# CONSERVATION DEPARTMENT DETAILED AGENDA

Date: April 21, 2022

#### 1. 86 & 88 South Shore Drive-NOI-Raze and rebuild of a single family home and associated site work-DEP File# 300-XXXX

EXISTING SITE PLAN

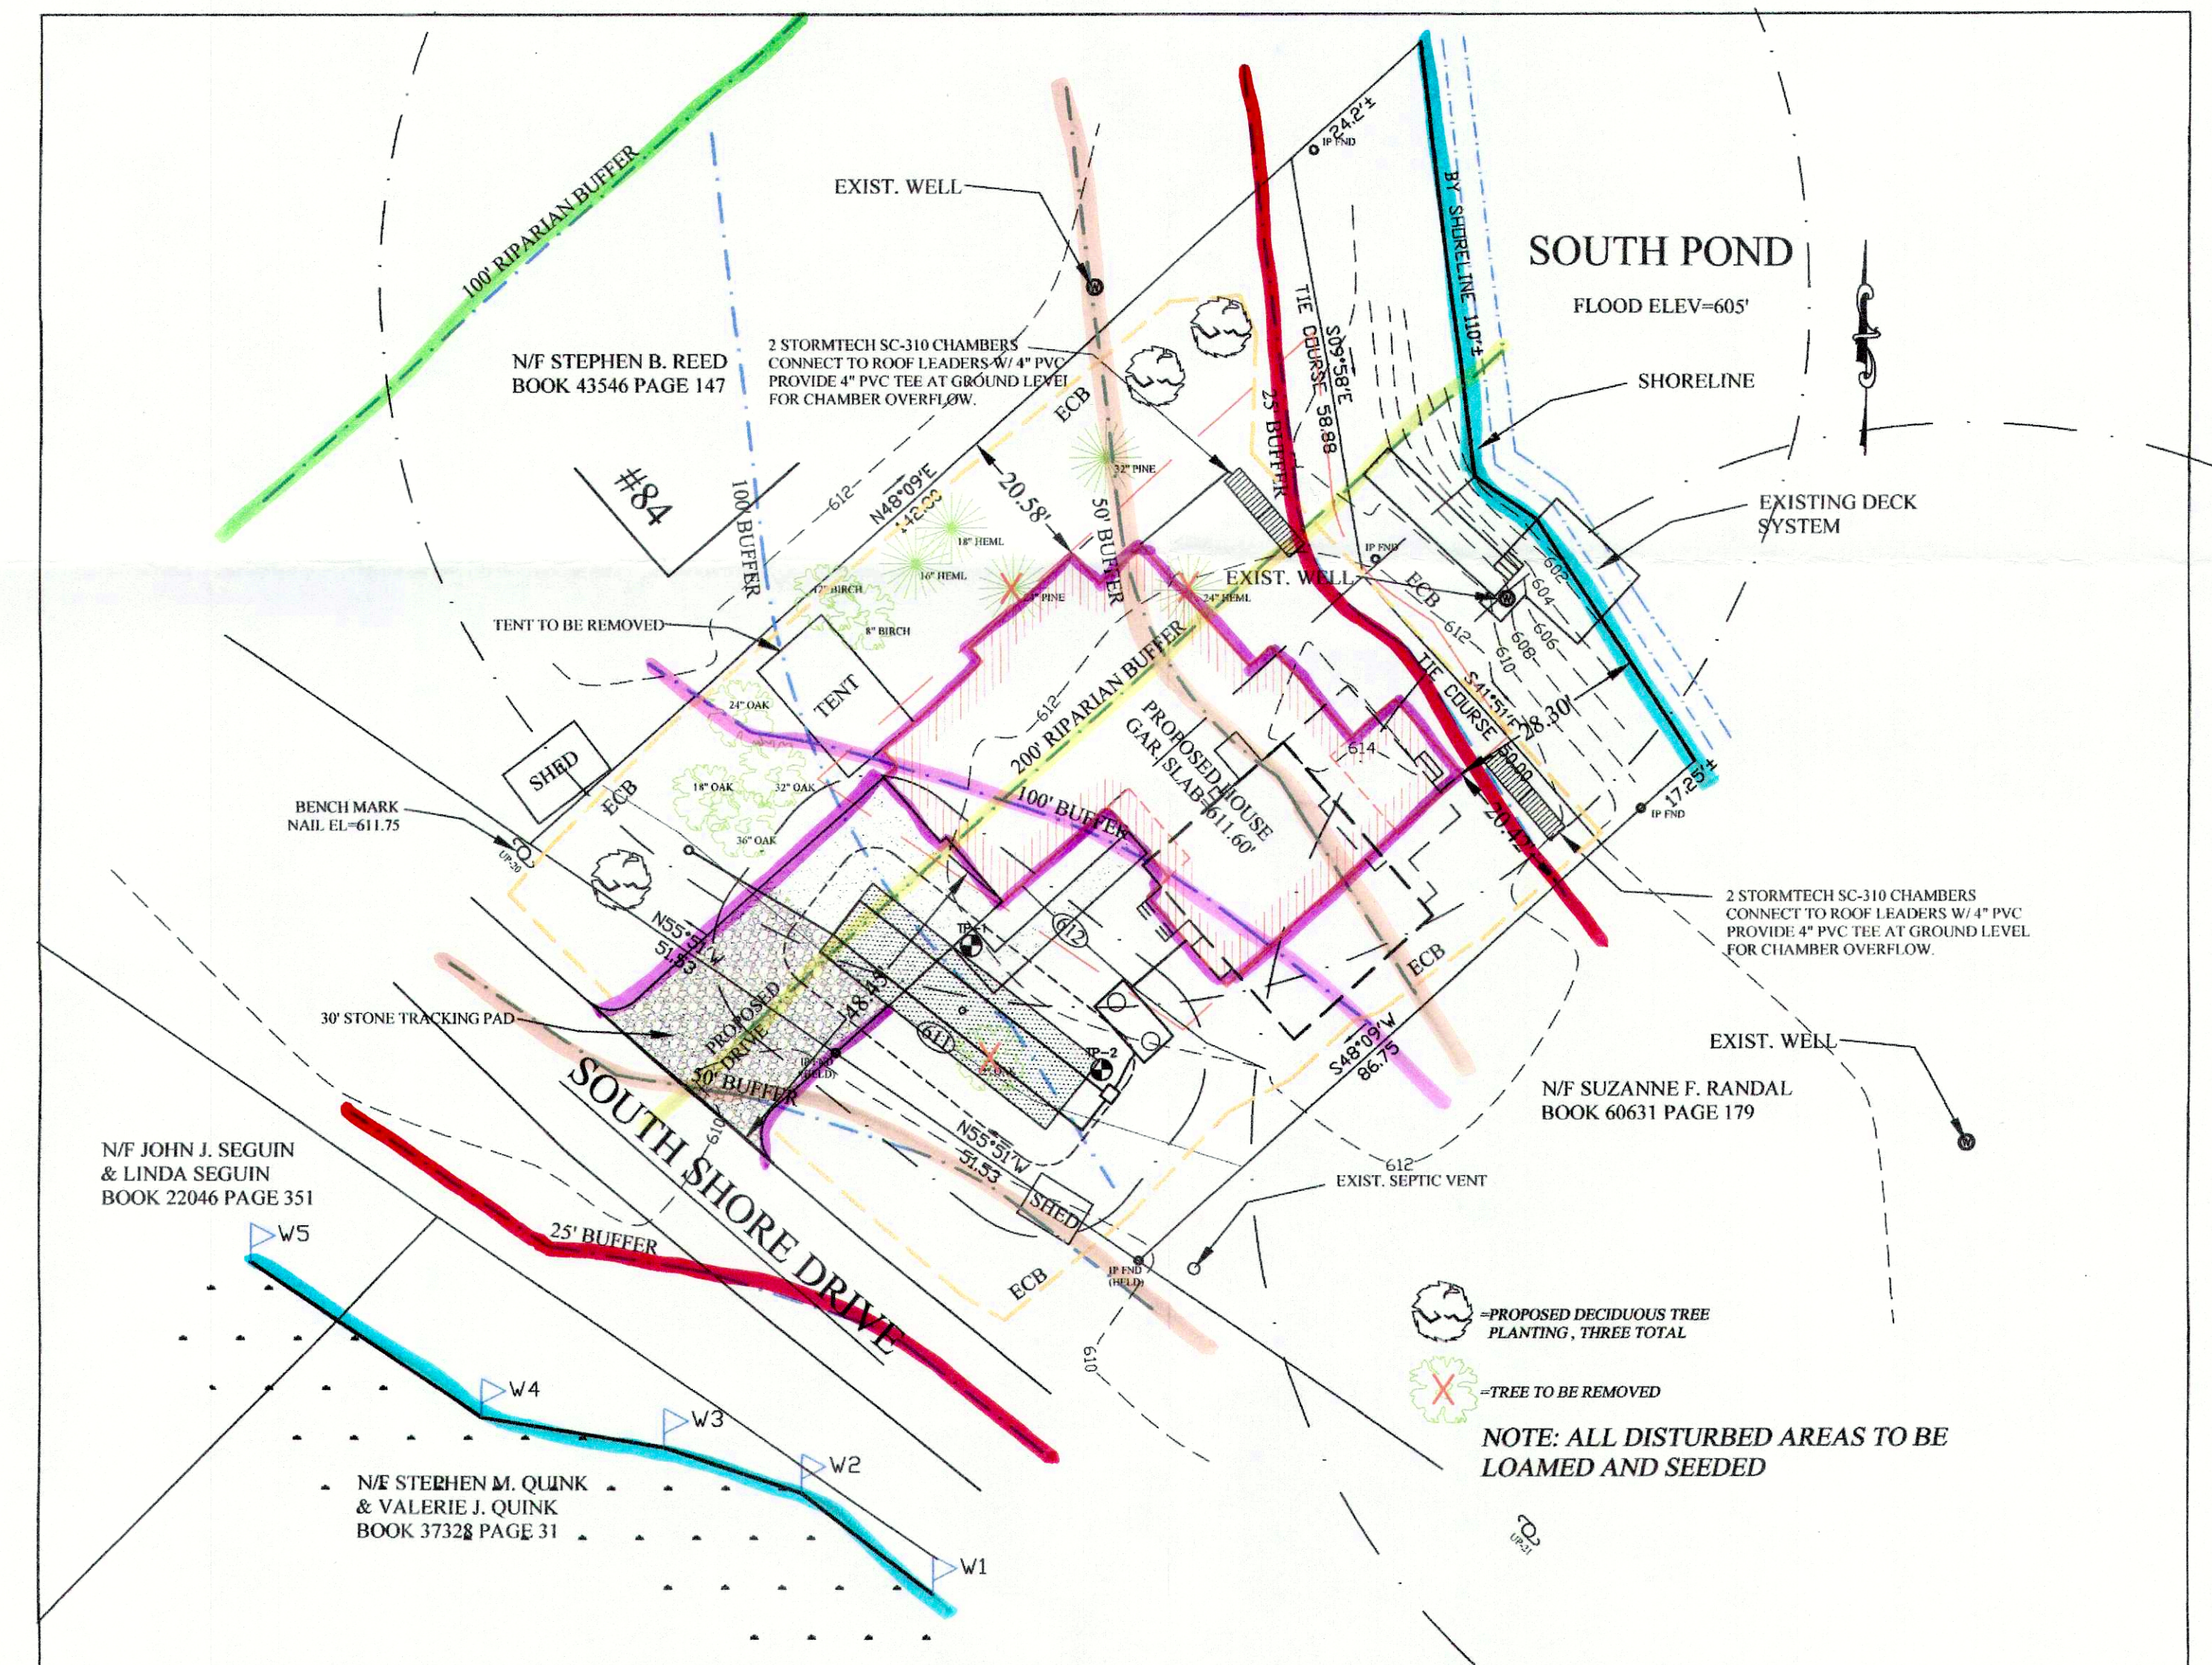
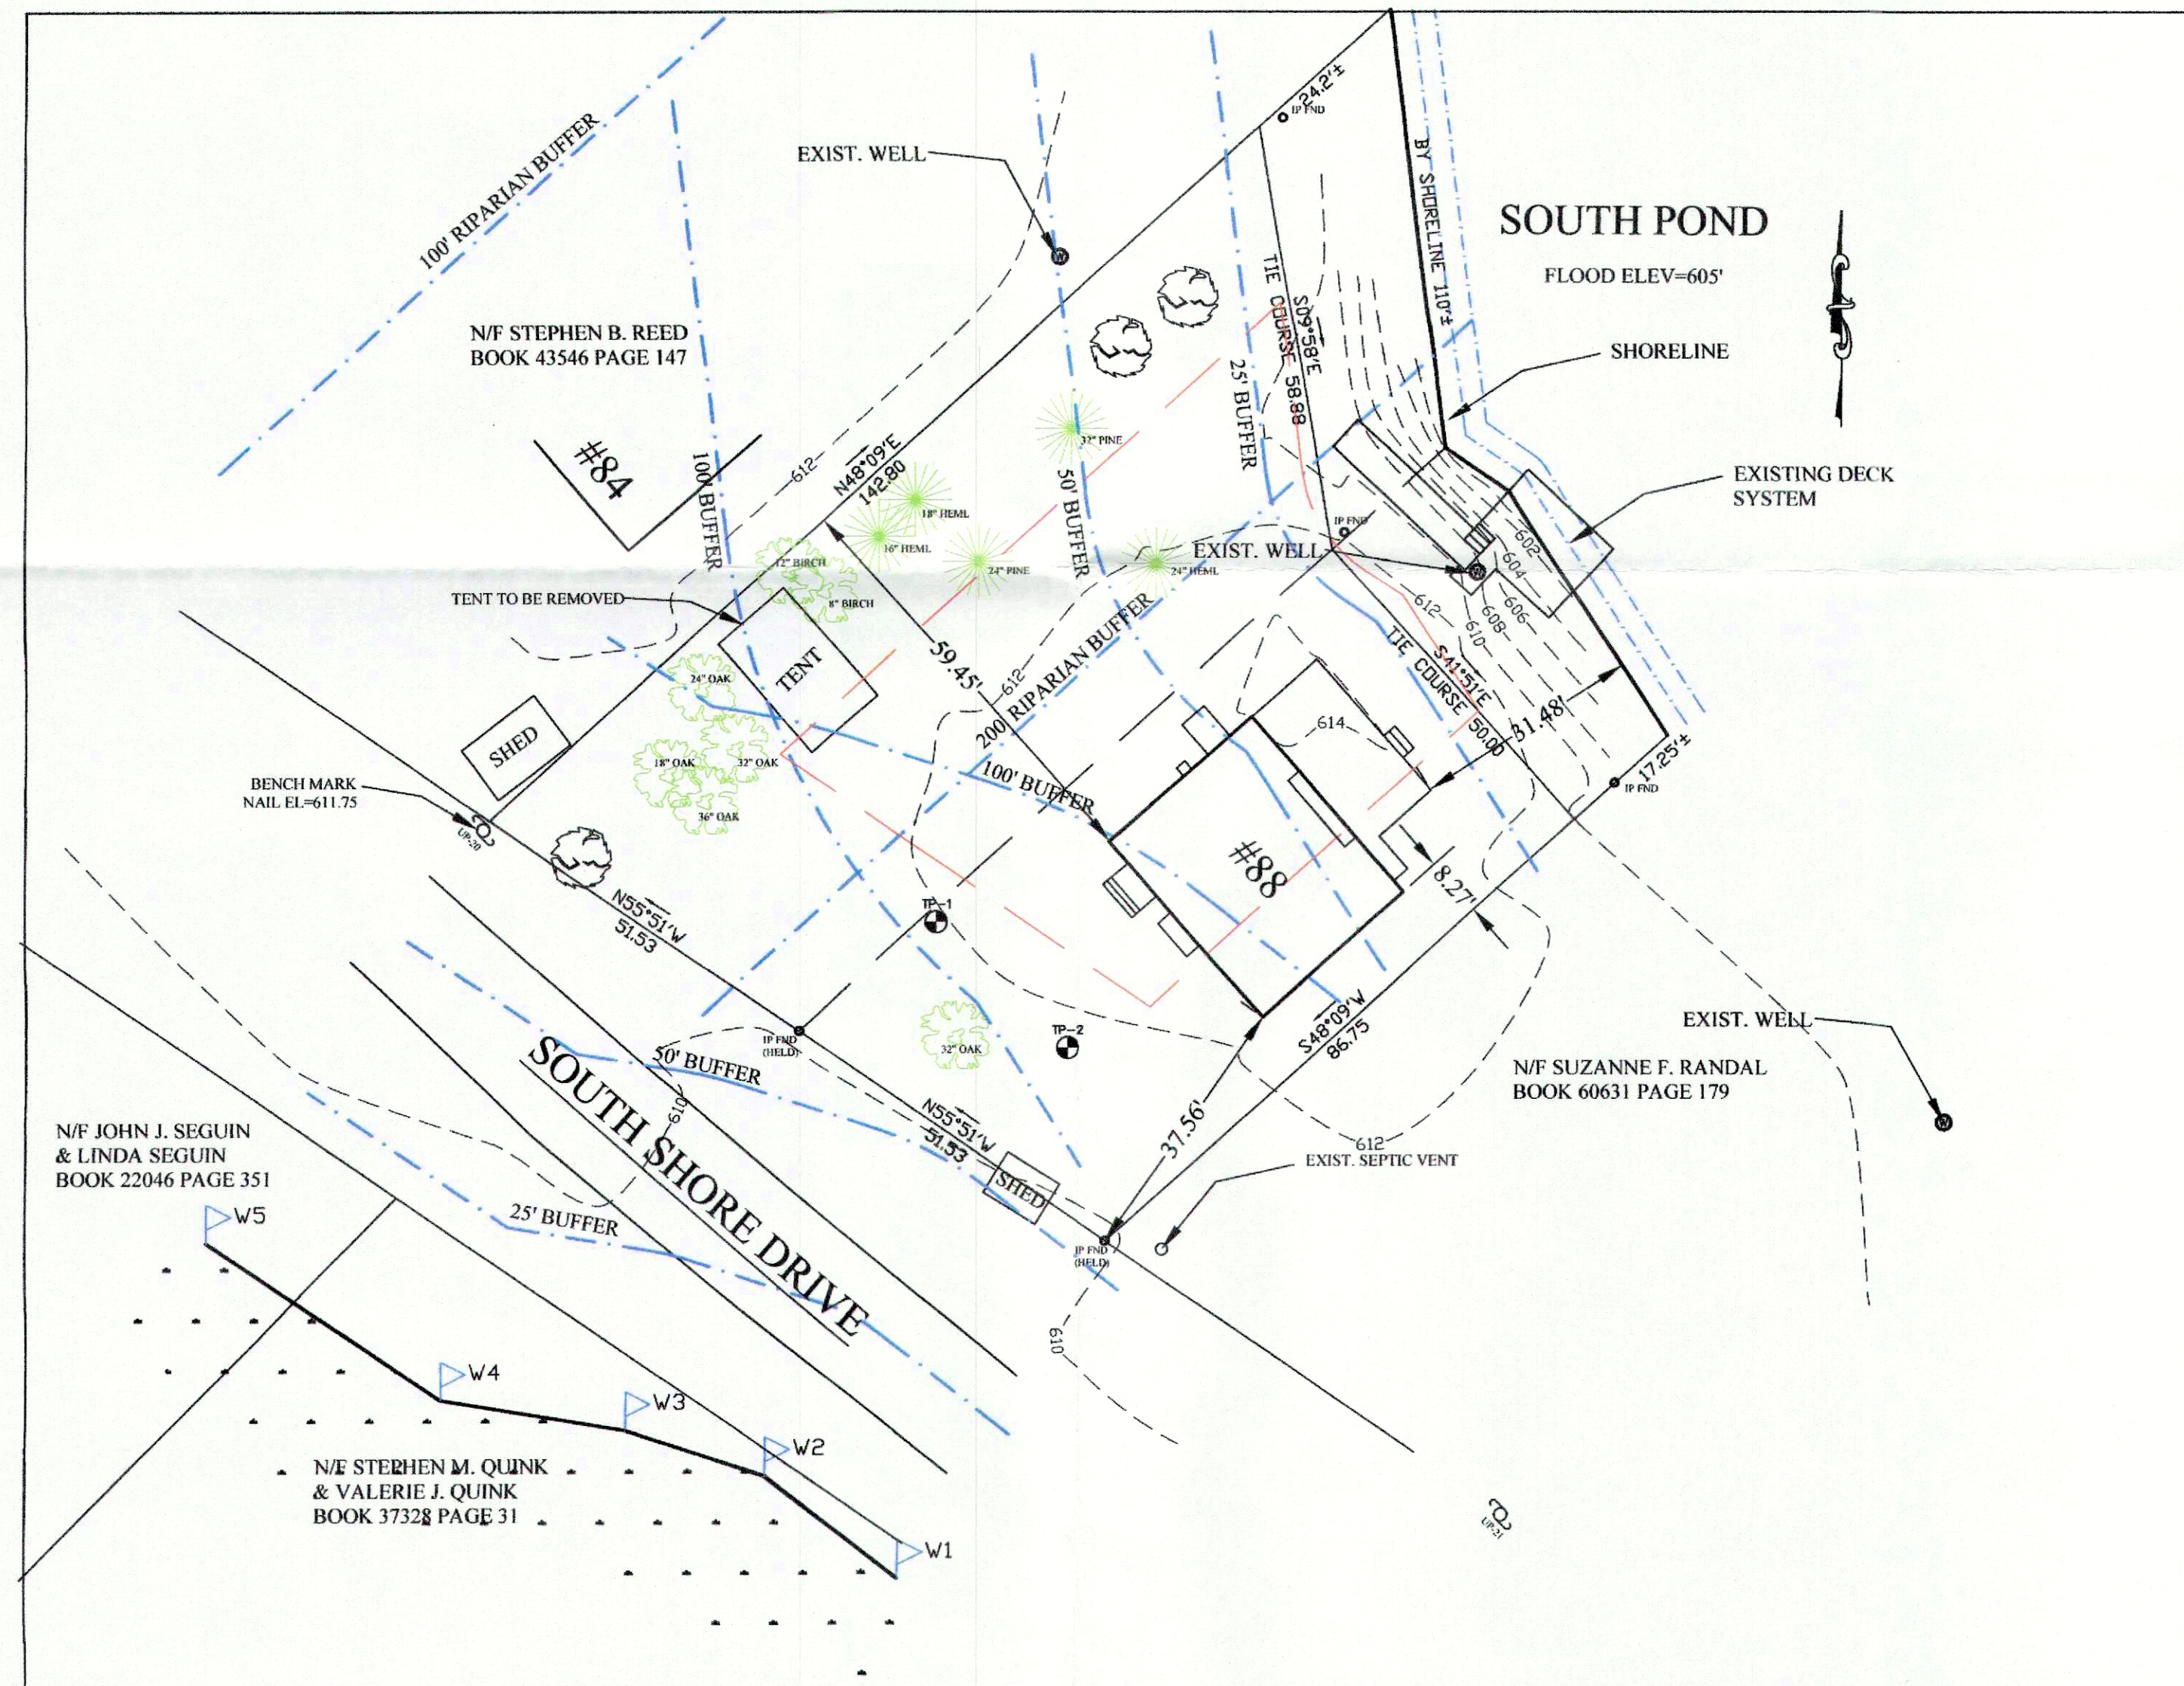
- Lot coverage has significantly increased and expansion is proposed within the 50 foot no new structure setback. 3 mature trees proposed to be removed as part of the project. Work would require a waiver under the SWB.

"This project has not yet been filed with this Department, but ZBA approval will be required. In general, the proposal will bring the side setbacks more into compliance than existing and that will be viewed positively by the ZBA. The lot coverage is increasing from 11.72 to 18.49%, where the maximum permitted is 15% without a special permit. The applicant will need to demonstrate why the increase in required and will also need to apply for a special permit to increase the lot coverage. I am not certain that this will be approved, that will depend upon the information provided by the applicant to the Board and if there are any excessive requests being made."

- Staff Recommendation: Continue to the next hearing, 5-12-22, as DEP has not issued a file. Application is not incomplete. Applicant must demonstrate full compliance with RA performance standards outlined in the WPA and SWB, demonstrate compliance with ability to receive a waiver under the SWB, provide an alternatives analysis and BVW data sheets.

PROPOSED SITE PLAN  
STEVEN M. AND MEAGHAN E. TARDANICO  
290 CLARKE ROAD EXTENSION  
STURBRIDGE, MASSACHUSETTS

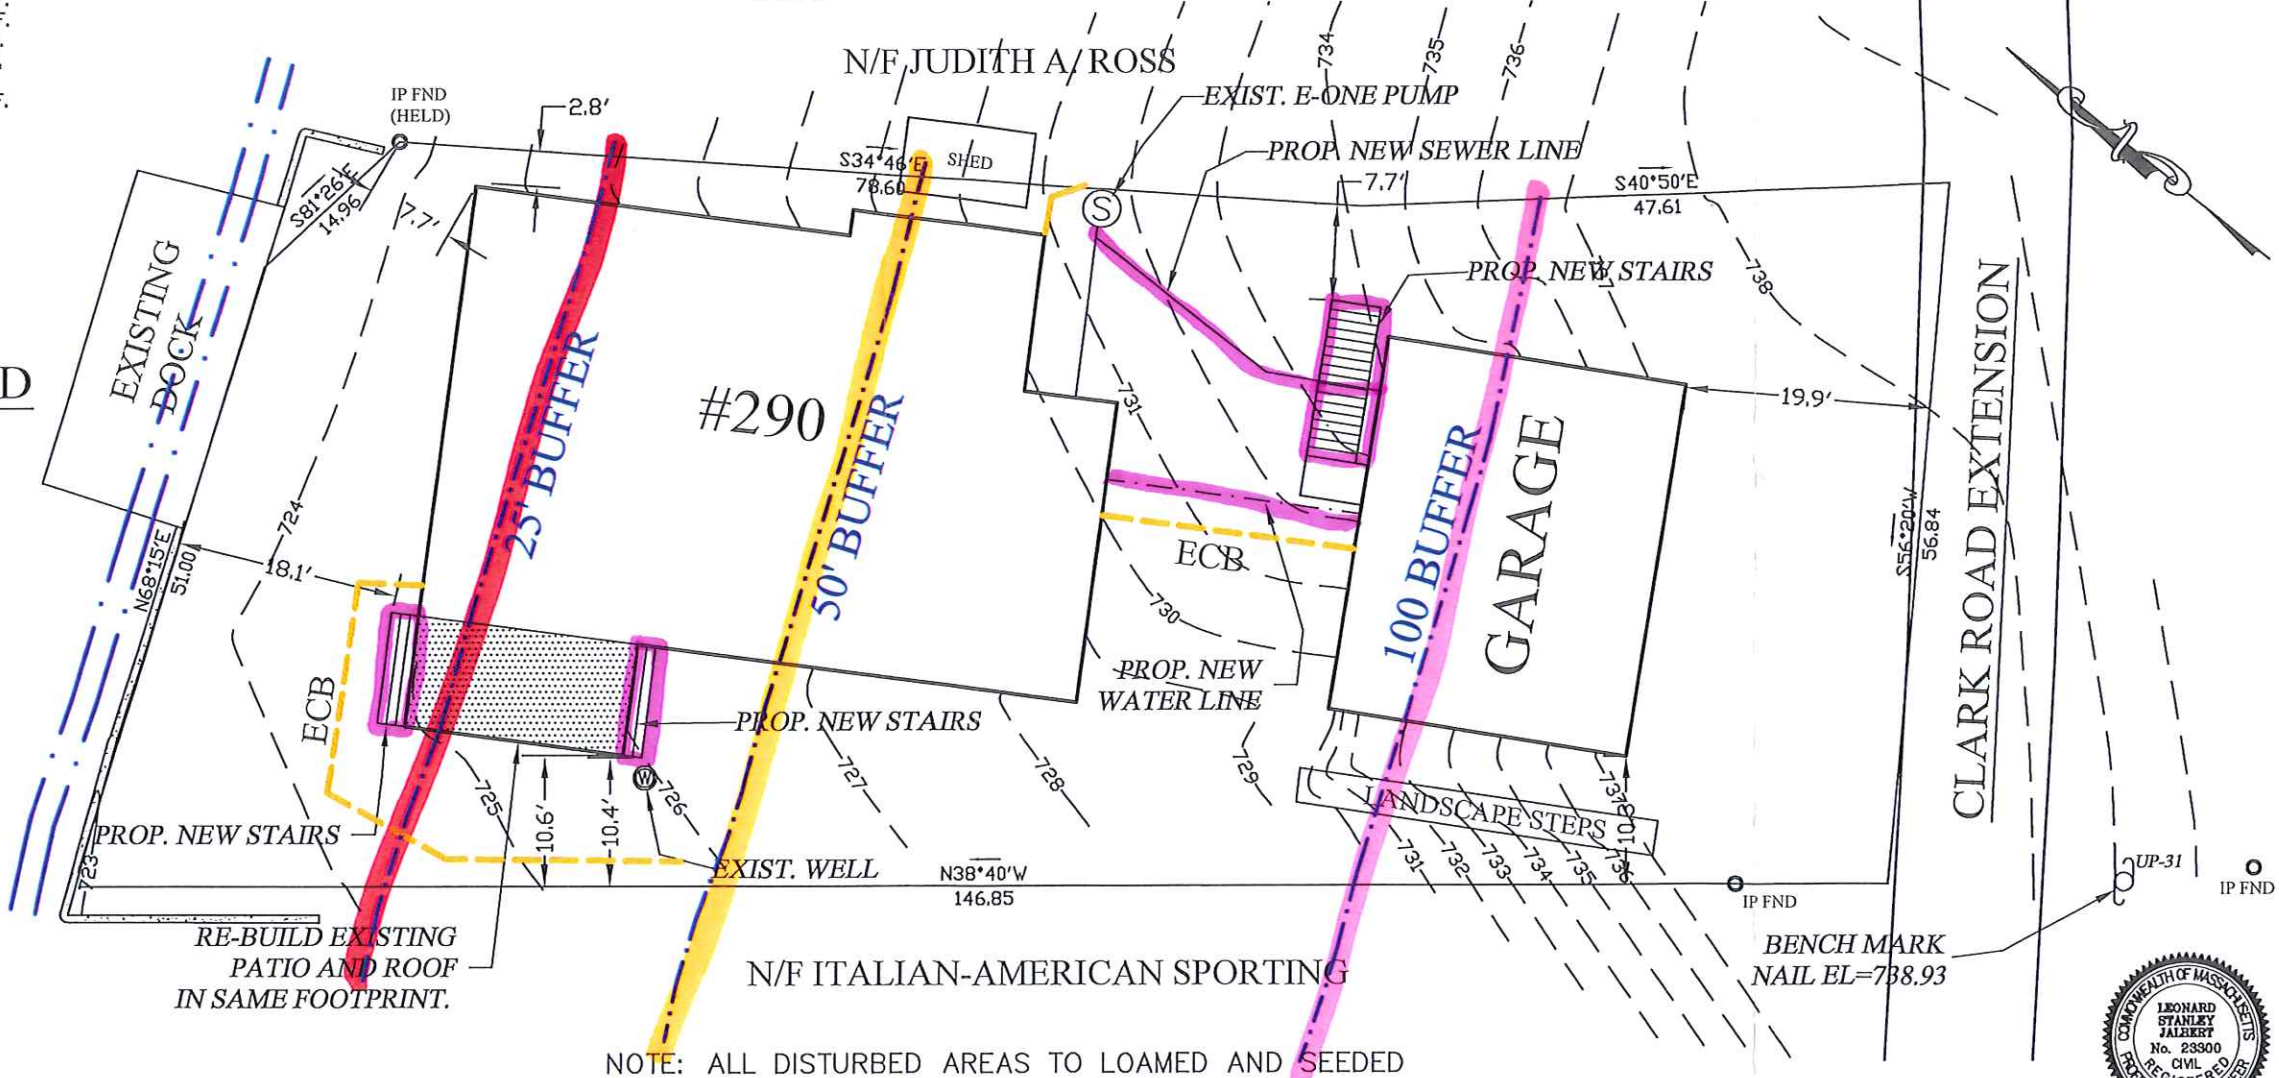
- Proof of abutter notifications received. Proof of legal ad required.
- Project site is not located within Priority or Estimated Habitat.
- No DEP Comments.
- Site contains Bank and work is proposed within the buffer zone.
- Site visit performed. Concerns noted about observed erosion noted from site runoff issues.
- Staff could not locate a file for when the site was redeveloped.
- No overall concerns noted with project however erosion and drainage concerns should be addressed.
- Staff Recommendations: A plan shall be developed to address erosion concerns on site. Continue to the next hearing, 5-12-22 to provide additional information.
